**Consulting regarding proposed repeal of the 2024 MATS Rule**

**C-25-EDF-1**

**Environmental Defense Fund**

**August 7, 2025**

Figure 1. Coronado Generation Station PM emissions over 20 operating quarters (annotation added)<sup>21</sup>

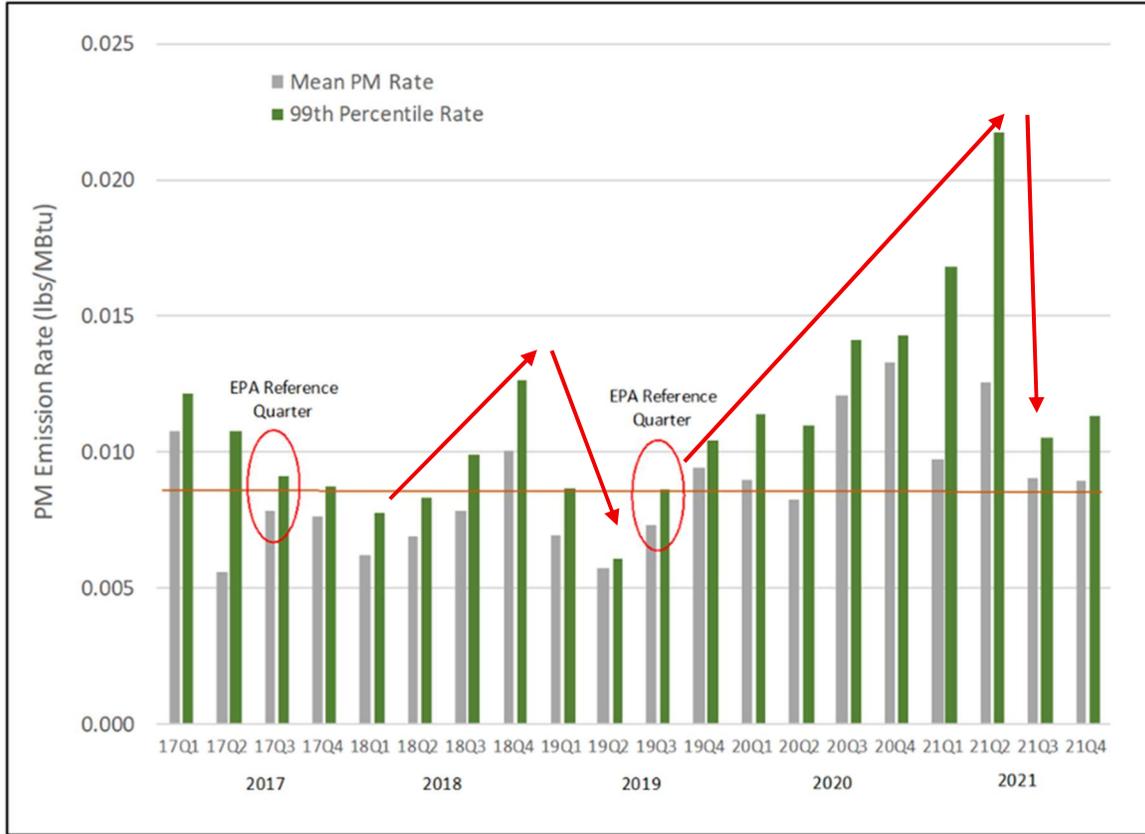
quarters with increasing emissions before reducing its emissions. Coronado was equipped with a PM CEMS. This data demonstrated that the plant was indeed capable of controlling PM emissions to below 0.010 lb/MMBtu. See Figure 1, which shows the mean fPM rate and the 99<sup>th</sup> percentile fPM rate. The figure also shows the two EPA reference quarters used in the rule development. Presumably, Coronado, equipped with ESPs, should have had ability to monitor parameters such as “opacity, secondary corona power, secondary voltage (i.e., the voltage across the electrodes), and secondary current (i.e., the current to the electrodes).” However, if a plant such as Coronado didn’t have the ability to monitor these parameters, then EPA’s recommendation is clearly not a viable approach. If Coronado did have the ability to monitor all of these parameters, clearly, they are not using the information in the manner that EPA claims they would. Nevertheless, it is clear in Figure 1 that deteriorating performance extended over several quarters before being corrected – in one case two years from late 2018 through early 2021. The facility never actually exceeded or reached the limit of 0.03 lb/MMBtu. So, the motivation to address whatever was adversely impacting emissions could remain low for many quarters. Clearly, EPA’s suggestion that these parameters are useful for identifying equipment malfunctions that impact PM emissions is either not being practiced or is ineffective. Since EPA has not required monitoring of these parameters and has not provided any evidence that monitoring these parameters would be effective (and the data actually demonstrates otherwise), EPA’s recommendation is without any merit.

Commenters to EPA’s 2024 rule claimed that the differences between reported fPM emissions in quarters at the Coronado facility are the result of “myriad factors, likely chief among them the units’ duty and coal variability,”<sup>19</sup> rather than issues that could be corrected with the PM control device. However, their assertion is not supported by data. If the unit’s duty (or operating level) were a major factor, there would be seasonality to the PM emissions data that would track the seasonal duty of the facility, which is definitely not the case. Peak quarters would be the same year to year. If coal variability were a major factor, as asserted by the commenters, changes in coal composition and the fPM rate would track together, which they don’t. A closer look provides additional support for these points.

Figure 2. Coronado Operating Data, SO<sub>2</sub>, PM loading from coal, and generation (Developed from EIA Form 923)

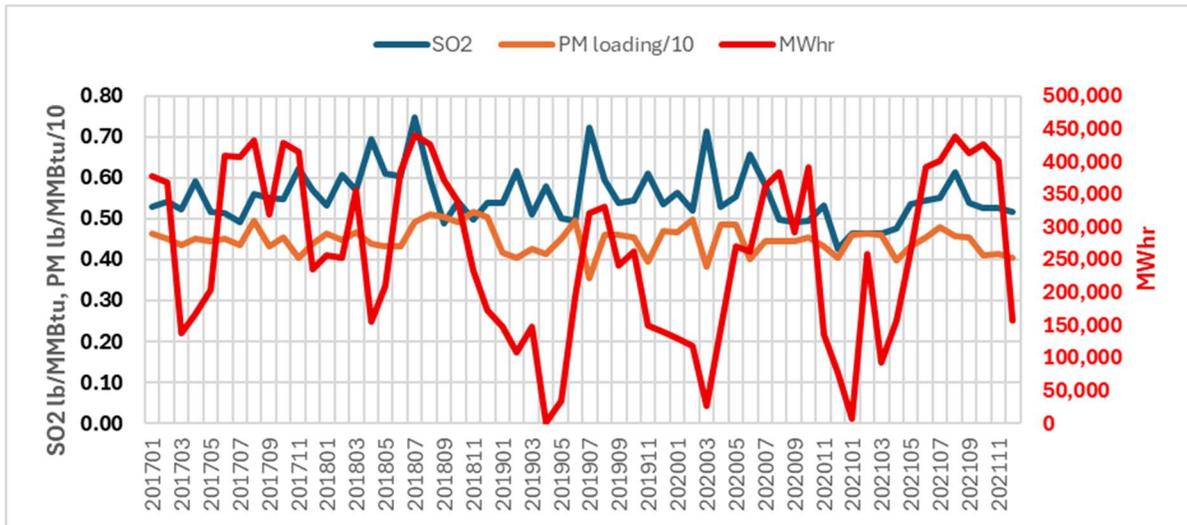
An examination of the Coronado coal data and operating data from EIA Form 923 over the same period does not explain the trends in Figure 1. Figure 2 shows monthly generation, PM loading (divided by 10 and assuming that 80% of coal ash becomes fly ash) and inferred SO<sub>2</sub>.<sup>20</sup> Figure 2 displays patterns of seasonality in generation: peaks in generation are consistently in July-August, and first quarters (January-March) are consistently low load periods. This is inconsistent with the PM data of Figure 1, which shows no seasonal trend. The variability in fuel characteristics in Figure 2 also shows no relationship with the quarterly PM data in Figure 1. The only reasonable reason for the trend in PM emissions at Coronado is that operators waited several quarters, and in one case over two years, to take corrective measures to improve the emissions rate.

Figure 3. Inferred SO<sub>2</sub> rate (lb/MMBtu) of Conemaugh Plant coal (developed from EIA Form 923)<sup>29</sup>

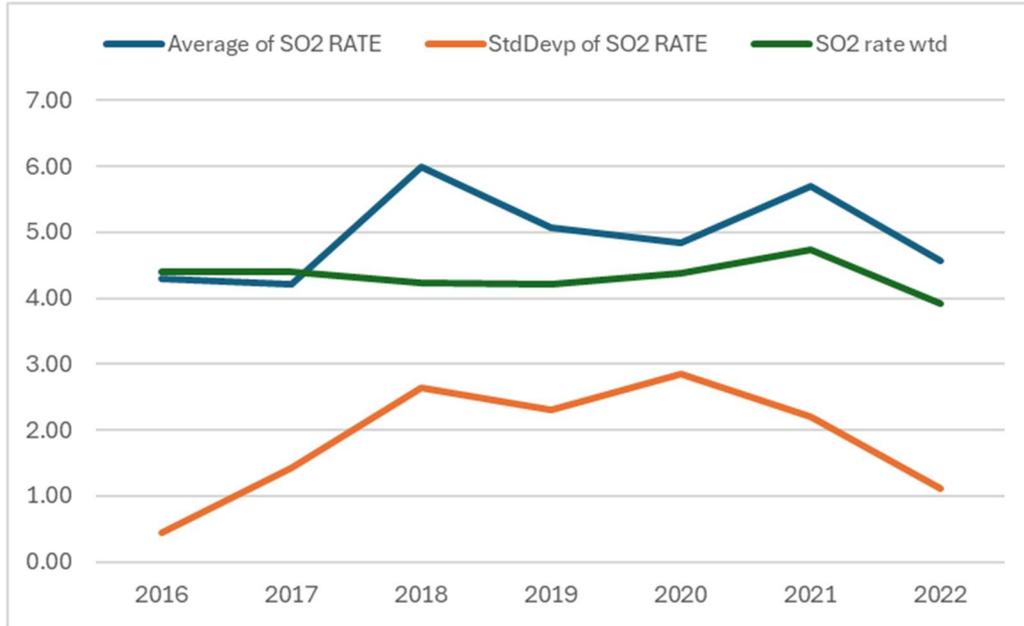
Figure 3 shows average inferred SO<sub>2</sub> rate (equal weighted average SO<sub>2</sub> of each coal delivery), the standard deviation of those inferred SO<sub>2</sub> rates, and the heat input weighted average inferred SO<sub>2</sub> rate (average weighted according to reported heat input of coals over the year).

Figure 4. Mercury content (lb/TBtu) of Conemaugh Plant coal developed from EIA Form 923)<sup>30</sup>

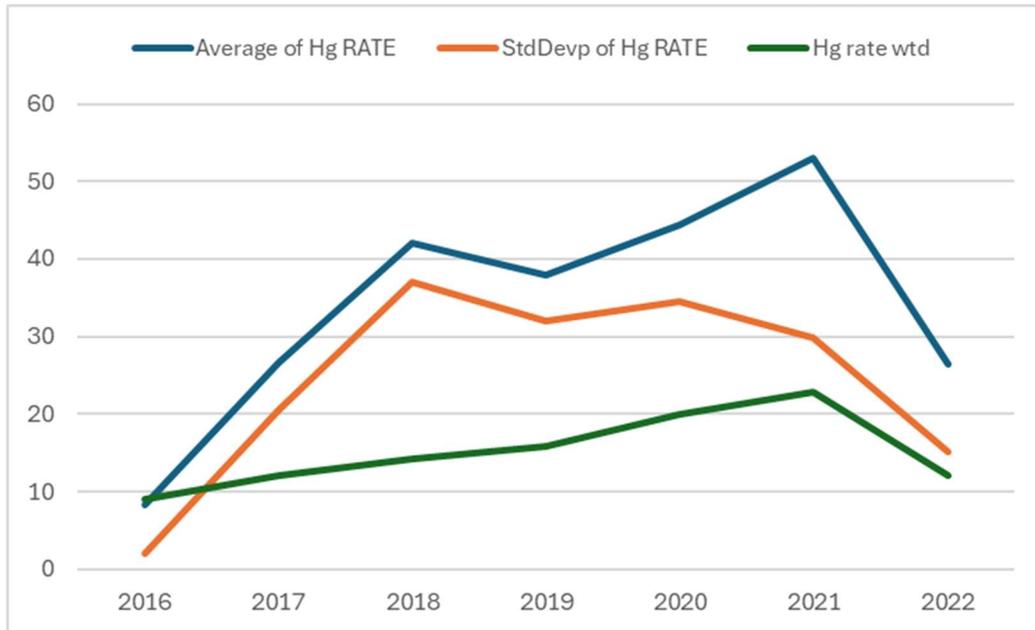
Figure 4 shows average Hg content (equal weighted average of Hg for each coal delivery), the standard deviation of those Hg contents, and the heat input weighted average Hg content (weighted average according to reported coal heat input over the year). The high standard

deviations of the Hg content and inferred SO<sub>2</sub> rate demonstrate that the coals are highly variable in chemical composition, which makes it more challenging to “tune” a control system.

*Figure 5. Annual average Hg emissions of the Conemaugh plant units 1 and 2 and average Hg capture, 2016-2022 (From EIA Form 923)*

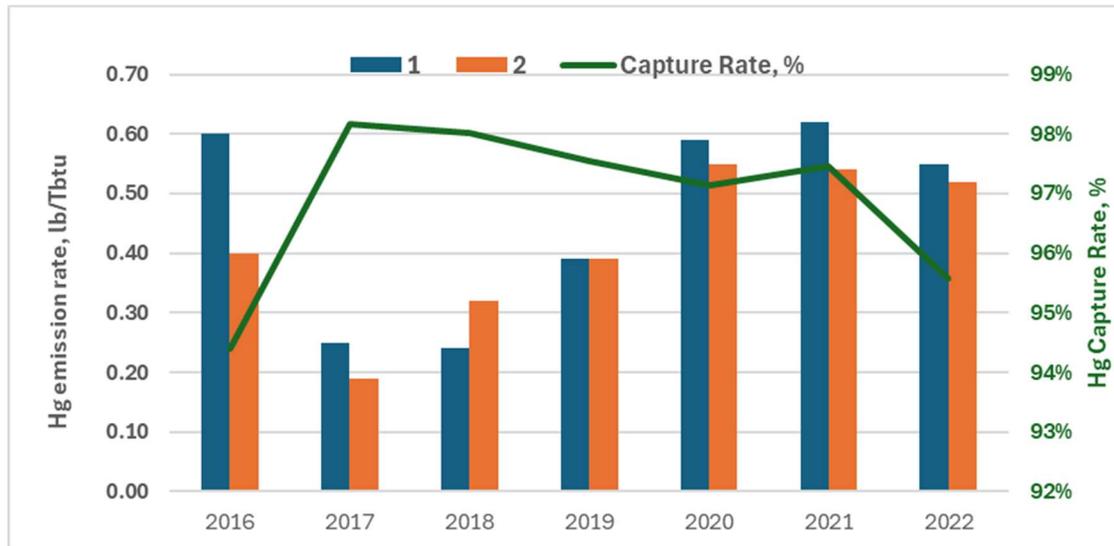
Using the heat input weighted average Hg rate and the reported Hg emission rates, it is possible to determine the capture efficiency at the plant. The Conemaugh plant has consistently

burned high Hg and high sulfur coal that is typical of western PA coals and has also consistently maintained its emissions well under 1.2 lb/MMBtu, as demonstrated in Figure 5. In any year Conemaugh receives coals from several different mines. As shown, the variability in Hg content (standard deviation) far exceeded even the heat input weighted average. Some Conemaugh coals had Hg content in excess of 100 lb/TBtu. Except in 2016, calculated capture efficiency has exceeded 95% in every year. As noted in the footnote accompanying Figure 4, the coal mercury data for 2016 appears unreliable. So, it is very likely that the capture efficiency was actually above 95% that year.

Figure 6. Average Hg content and standard deviation of Hg content for different lignite plant coals and for the Conemaugh plant during 2020.

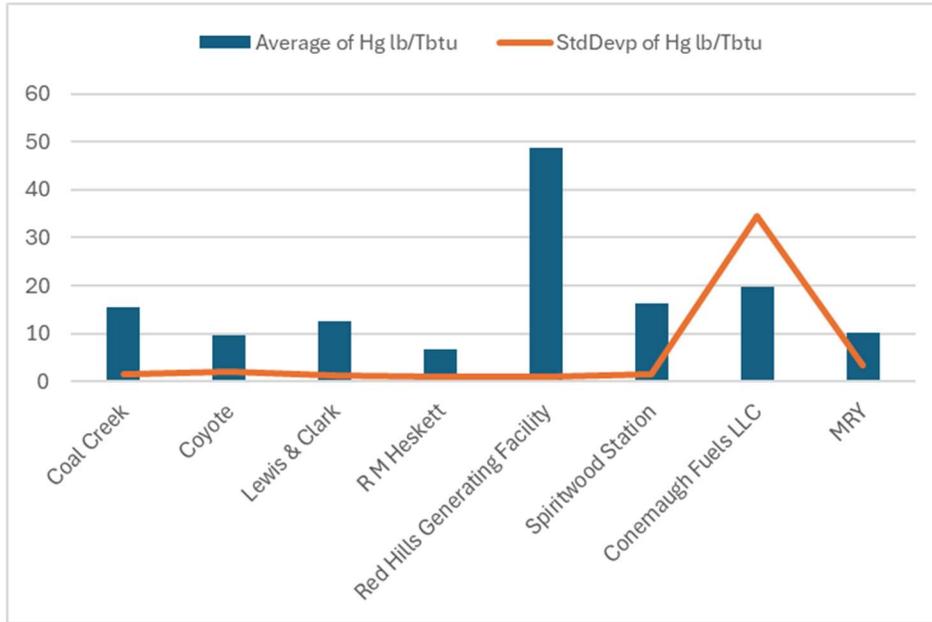
Coal variability also impacts the ease with which control equipment can be “tuned” to control emissions. Figure 6 compares the Hg content of lignite plant coals (and the standard deviation of that content) to that of the Conemaugh plant. All data is for the year 2020. The standard deviation shows the variability of Hg content of the coal. As shown in Figure 6, not only is the Hg content lower for most lignite plants, the standard deviation is also very low for lignite plants compared to the coal used at the Conemaugh plant. In fact, the variability in Hg content, as measured by the standard deviation of Hg content, for the Conemaugh plant coal exceeds the weighted average of the Hg content.<sup>31</sup> This is because, unlike most other coal units, lignite units are mine-mouth, and receive coal from only one mine. Most bituminous and subbituminous units receive coal from multiple mines, and therefore face much greater variability in coal. Thus, mercury content variability is much less for lignite units than for the Conemaugh plant, and likely less than for most non-lignite units that fire coal from a range of mines. This illustrates how lignite plants are fully capable of mitigating variability issues that other types of plants with greater variability have successfully addressed, as evidenced by the Conemaugh plant consistently achieving mercury capture rates exceeding 95%.

Figure 7. Comparison of SO<sub>2</sub> for different plants

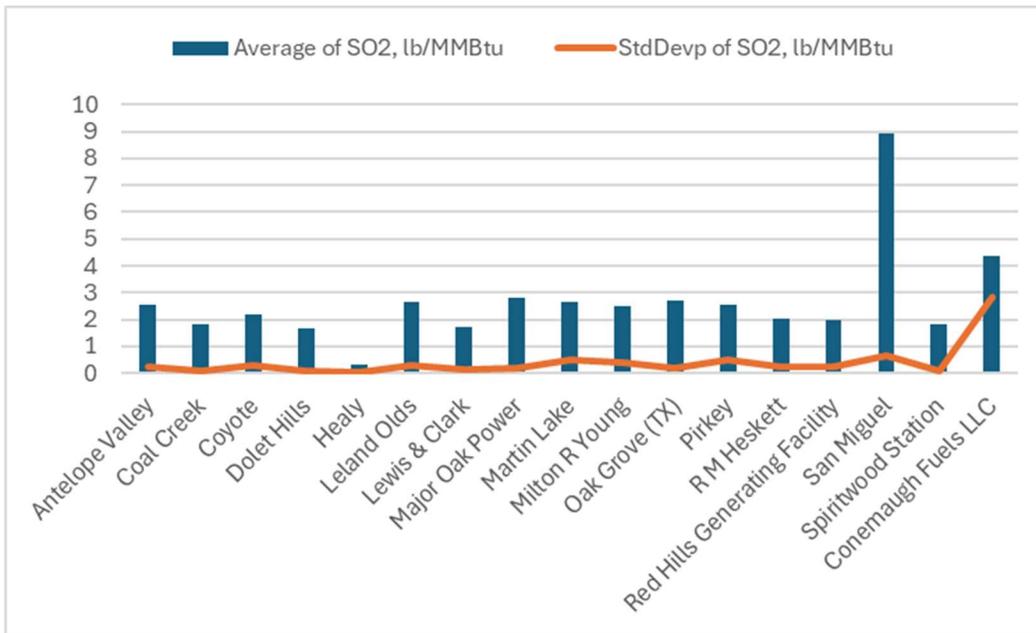
Sulfur content also is more variable at Conemaugh than at any of the lignite-fired plants. As demonstrated in Figure 7, Conemaugh has significantly higher inferred SO<sub>2</sub> levels than any lignite plant other than San Miguel, and has much higher variability, as indicated by the standard

deviation in inferred SO<sub>2</sub>, than any lignite fueled unit. In fact, San Miguel and Conemaugh have very similar configurations (ESP followed by a wet scrubber).
